Re: SSD 9835 Sydney Football Stadium Redevelopment – Condition B8(a) and (b) aero-acoustic report

Aero Acoustic Report – Design Impacts

ARCHITECTURAL SERVICES -
FACADE DETAIL - SUNSHADE
DETAILS SHEET 03

Design Confirmation – Structural Requirements set out in Aeroacoustic Report

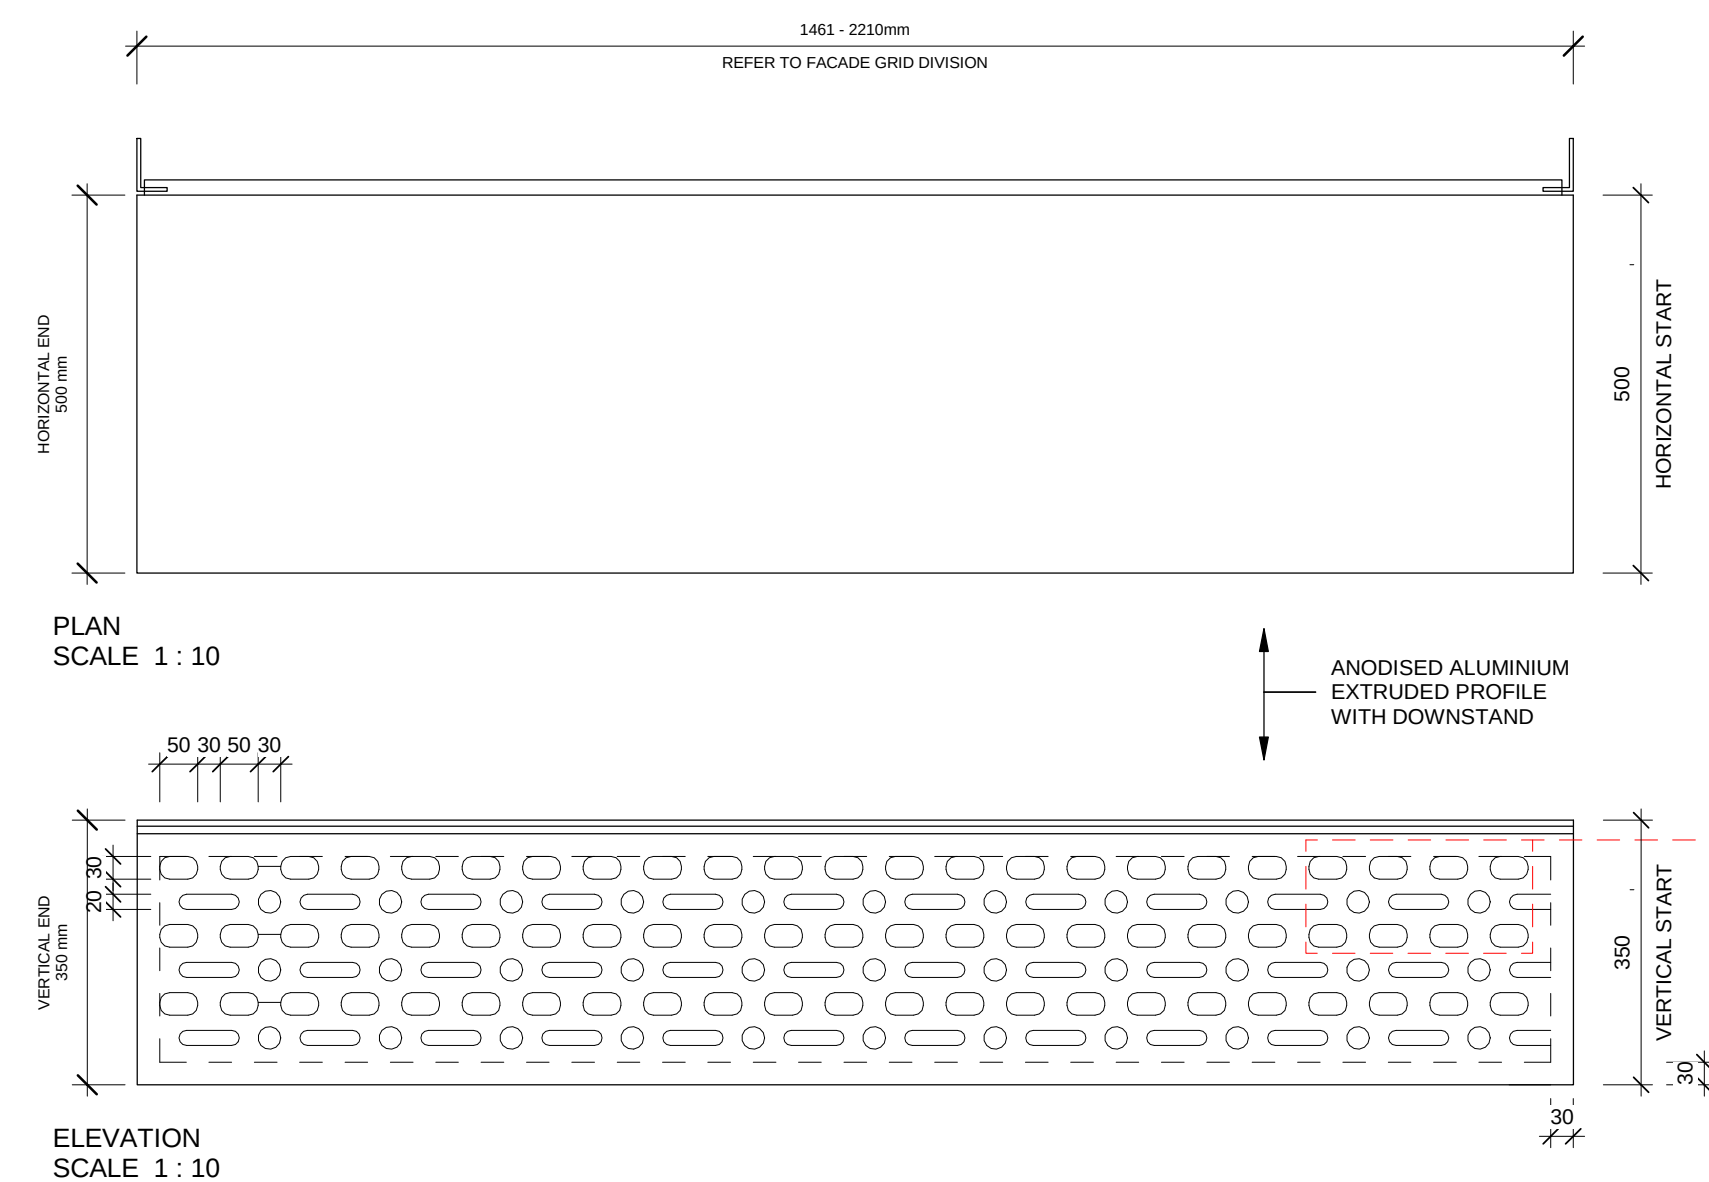
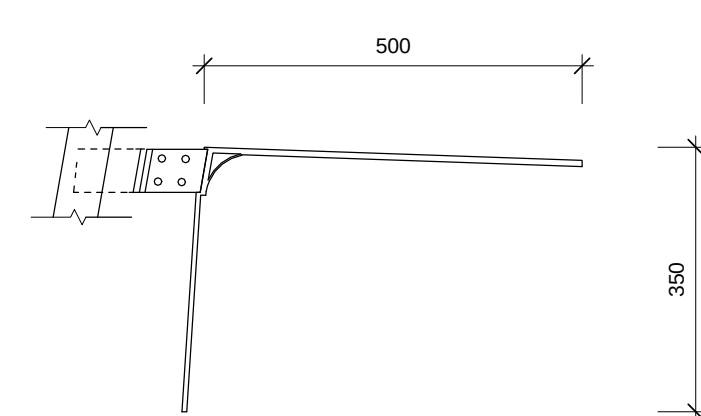
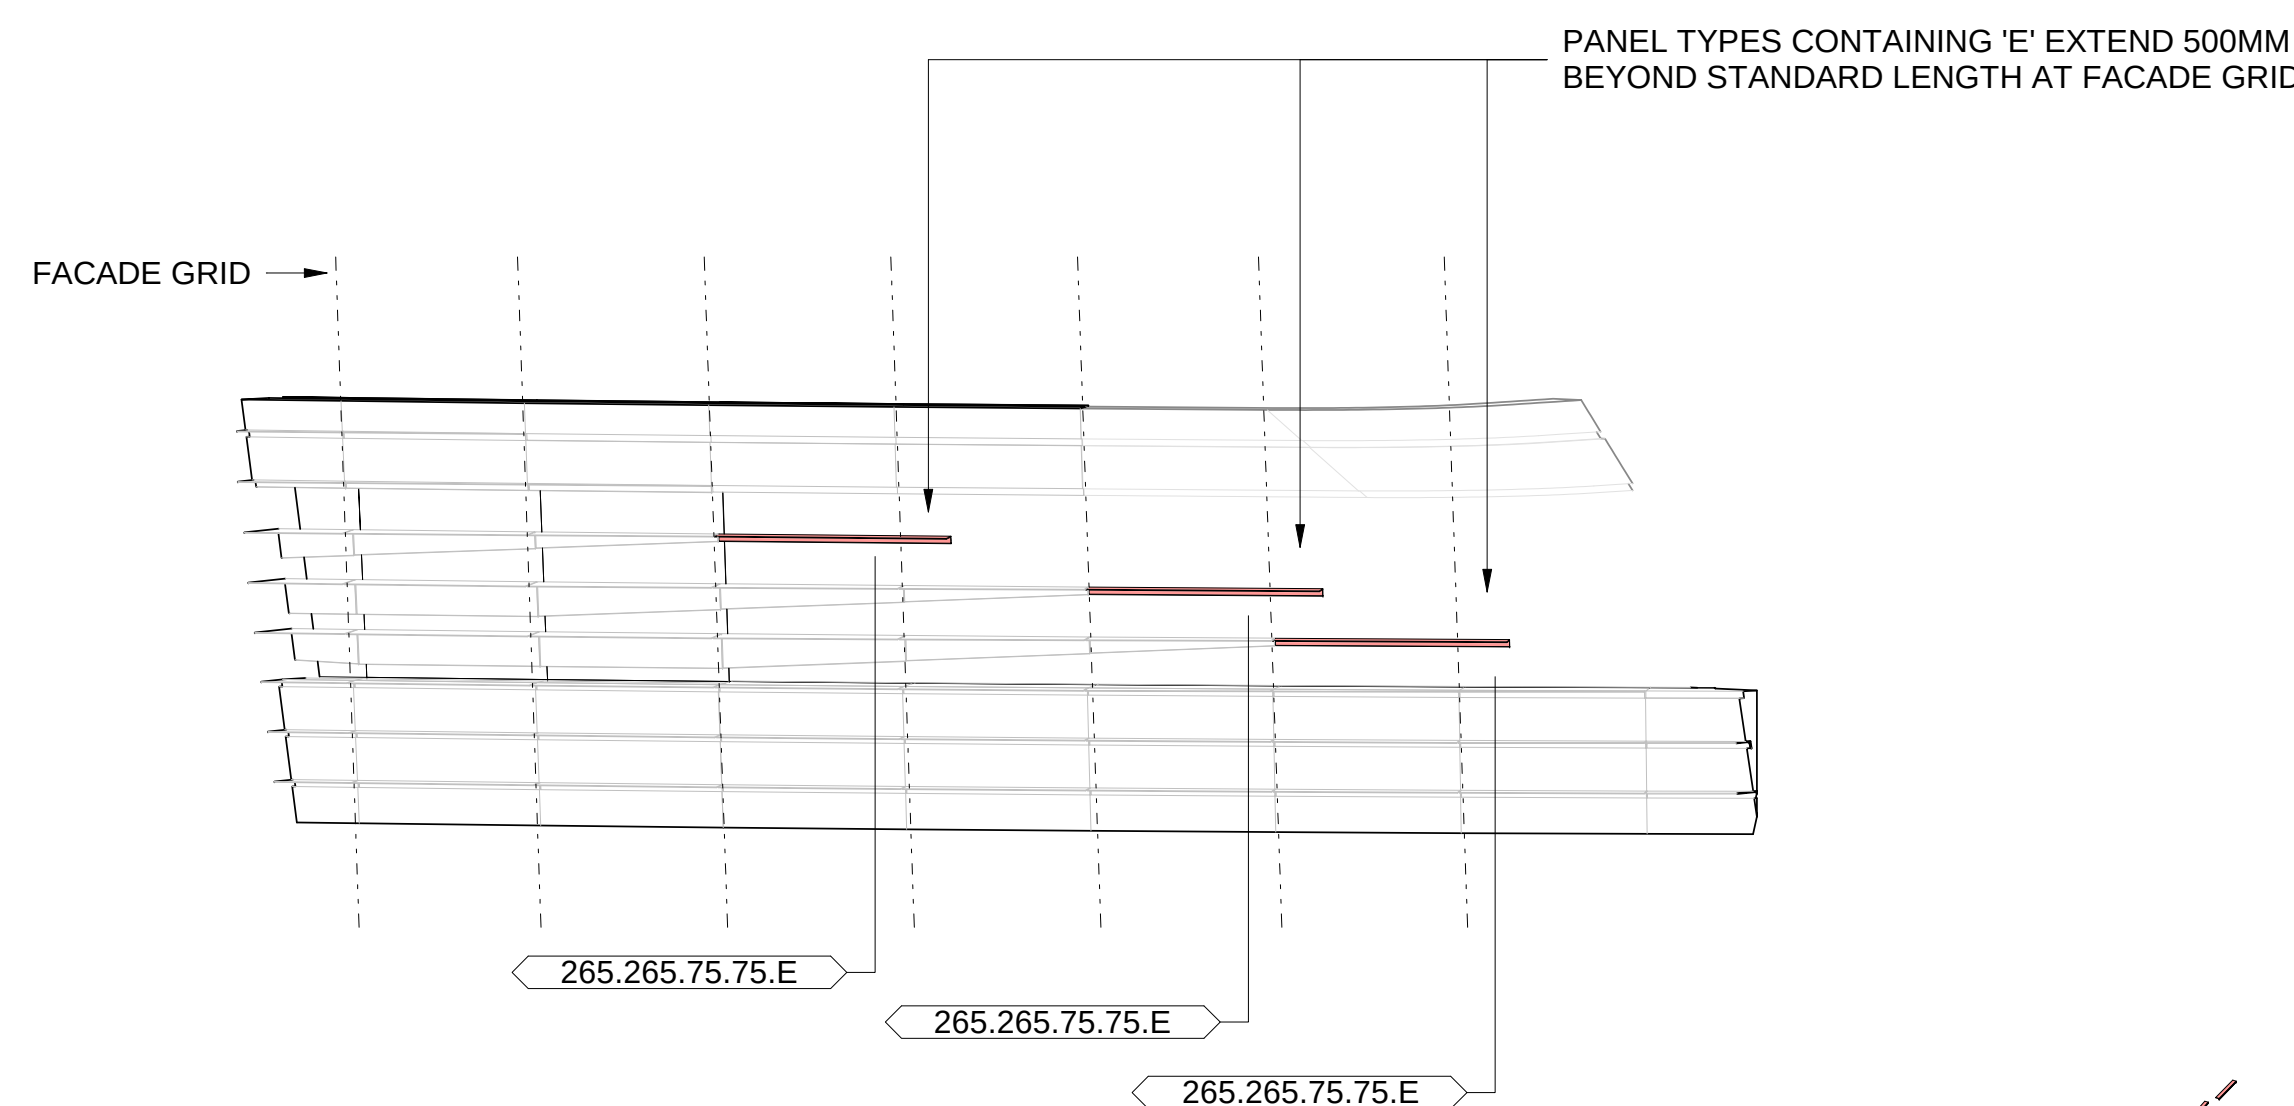
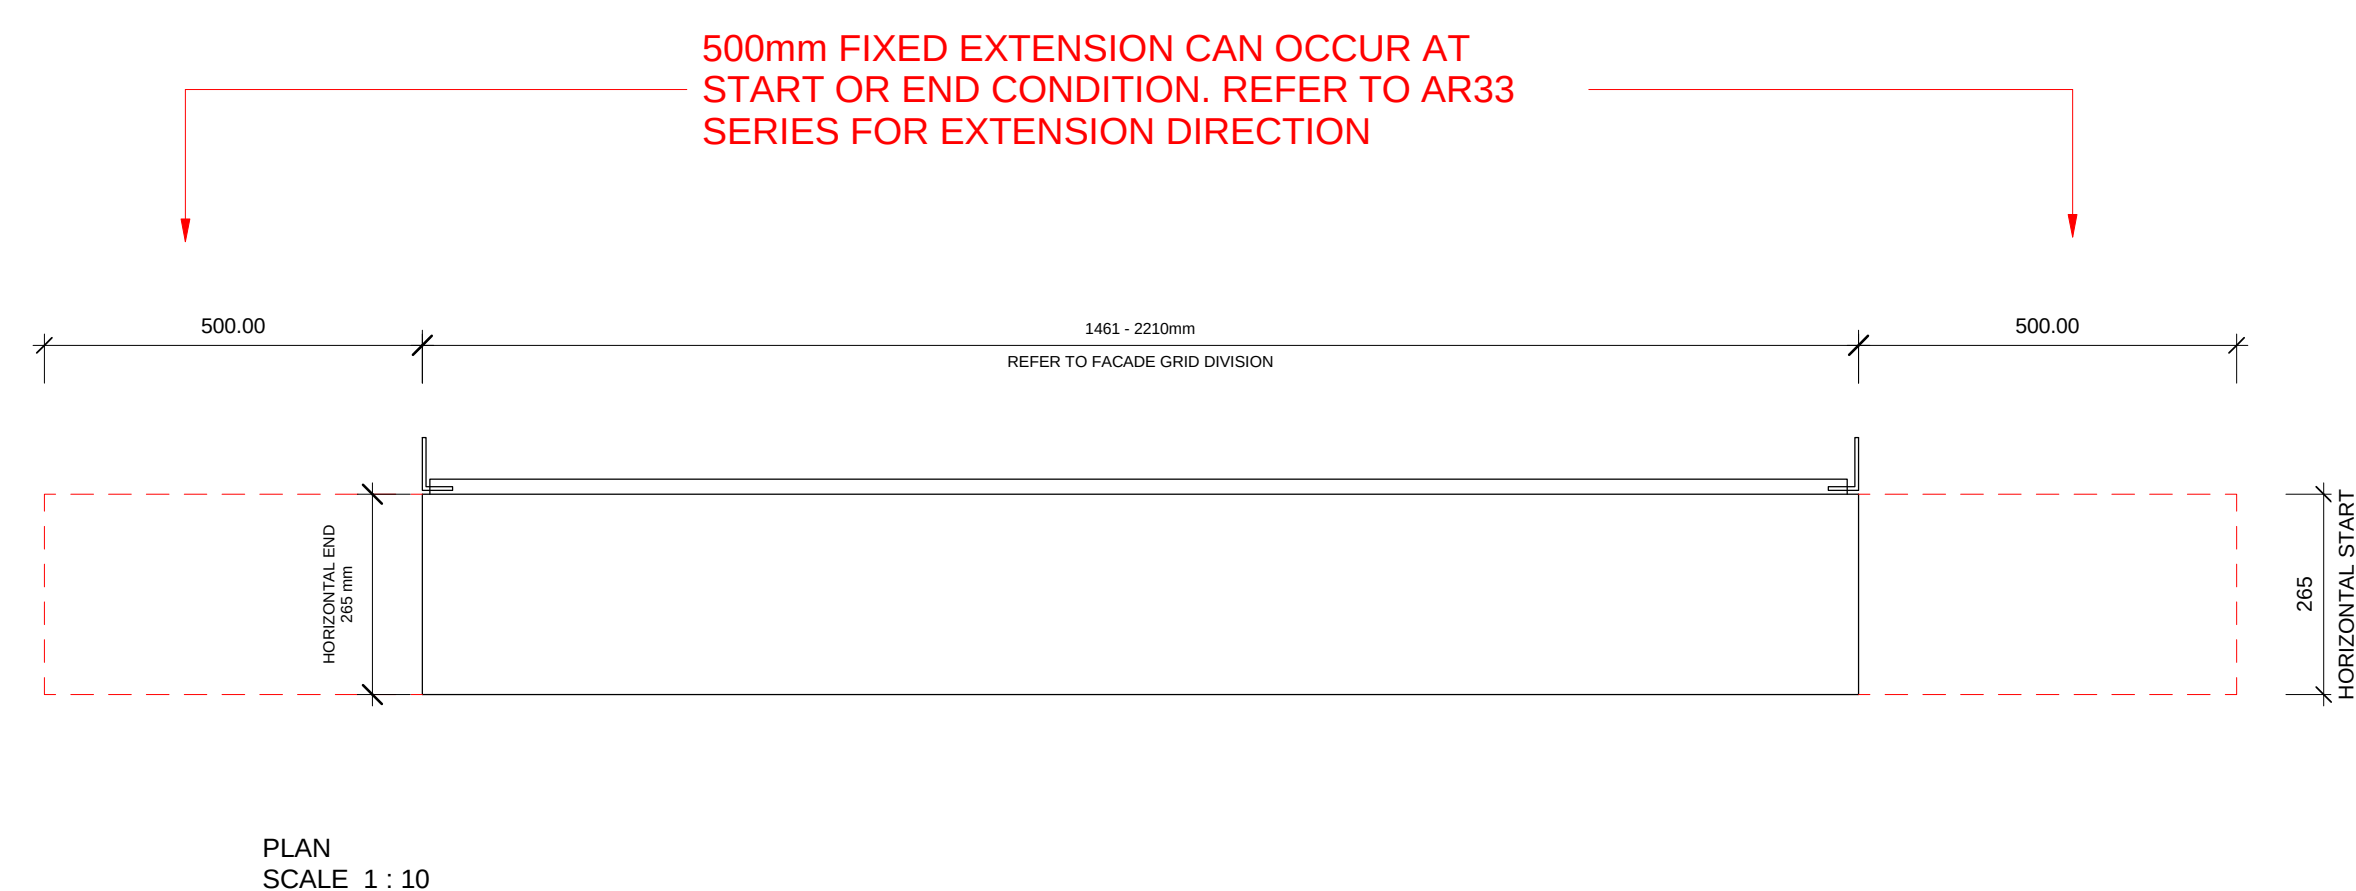
Cox confirm the perforation pattern has been updated to meet low risk category by varying hole pattern with 3 x different sized and shaped holes, with nothing smaller than 30mm diameter. For current hole pattern set out refer to attached drawing: SFS-COX-01-DR-AR60XX08[A]

The perforation matrix is to start centered on the rear sunshade face. Any holes that are cropped due to the solid perimeter are to be omitted as confirmed by COX Architects.

ASK461 - FACADE PERFORATED SUNSHADES SCOPE PACK

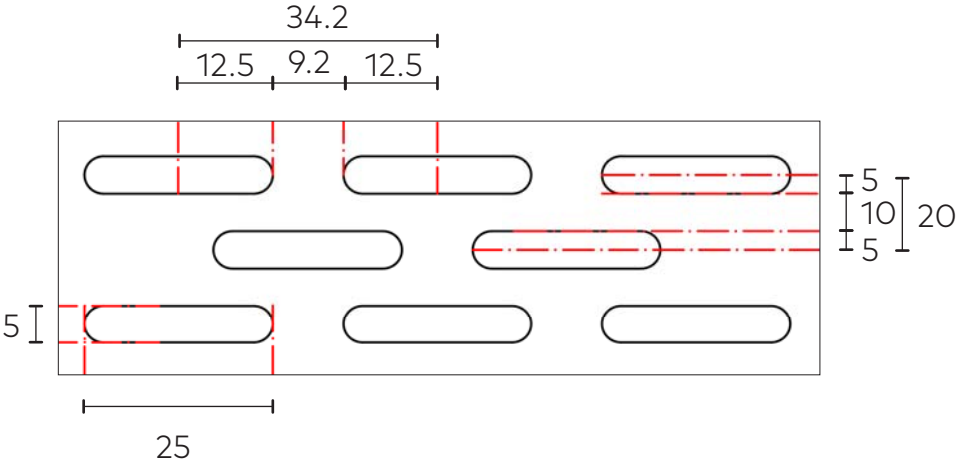
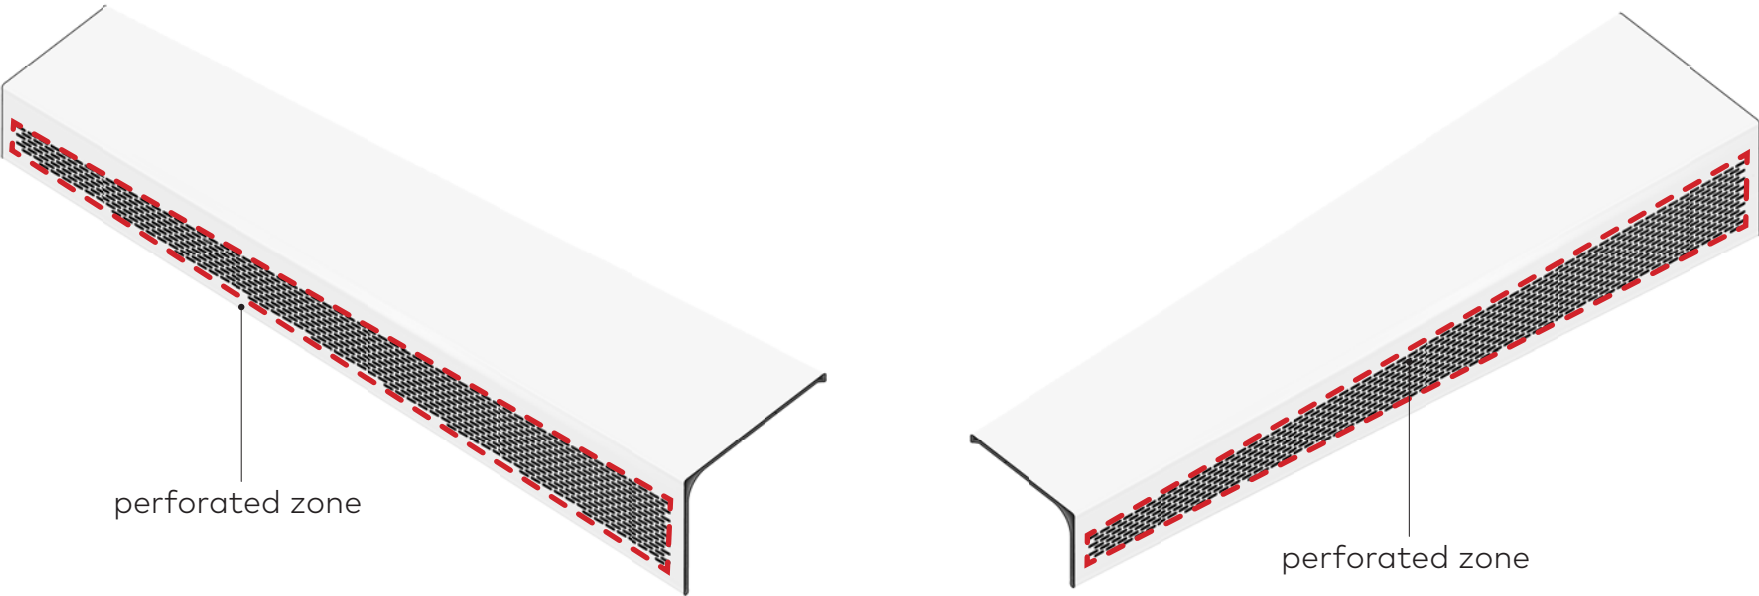
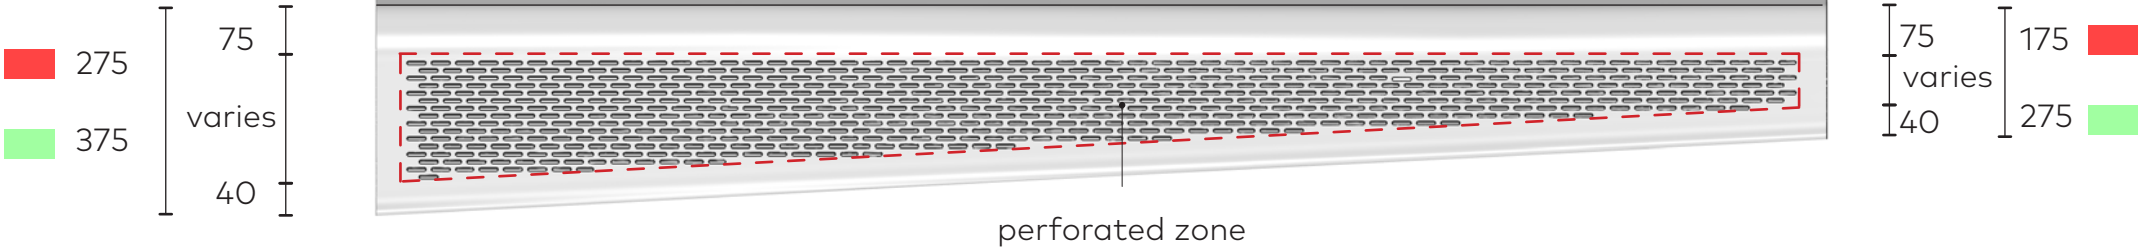
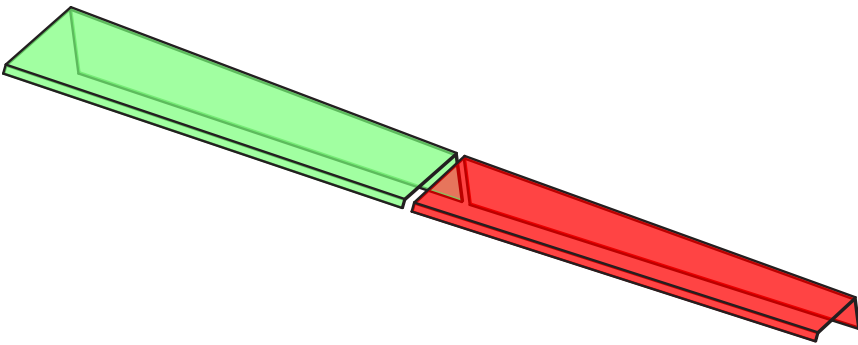
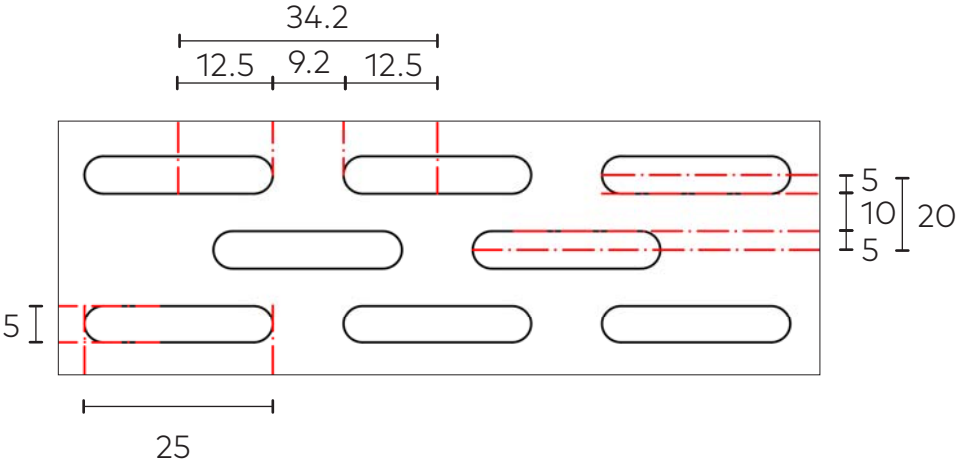
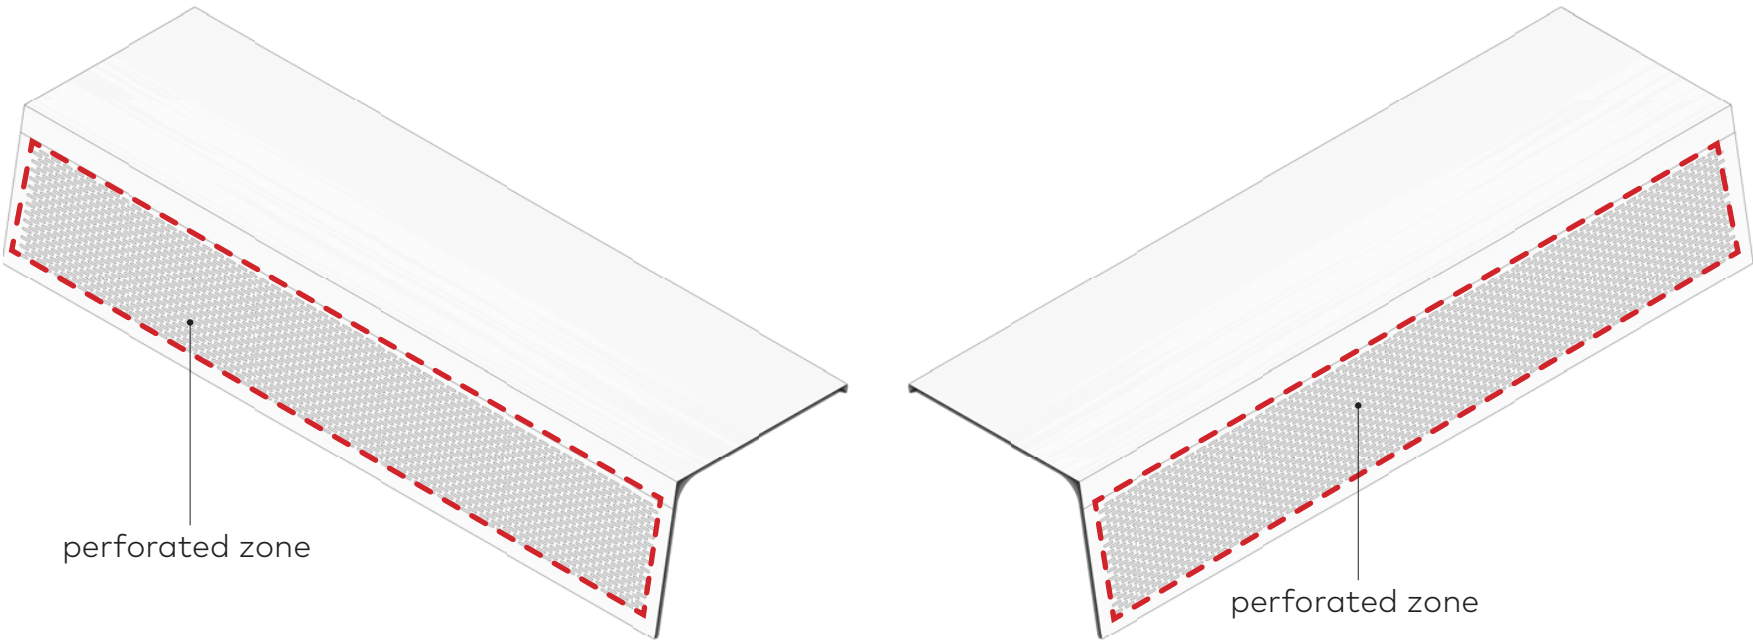
It was further developed by COX to become 25mm x 5mm slotted holes – refer ASK461-SFS_Perforated Sunshades Scope Pack.pdf.

The original concept was identified as a risk.
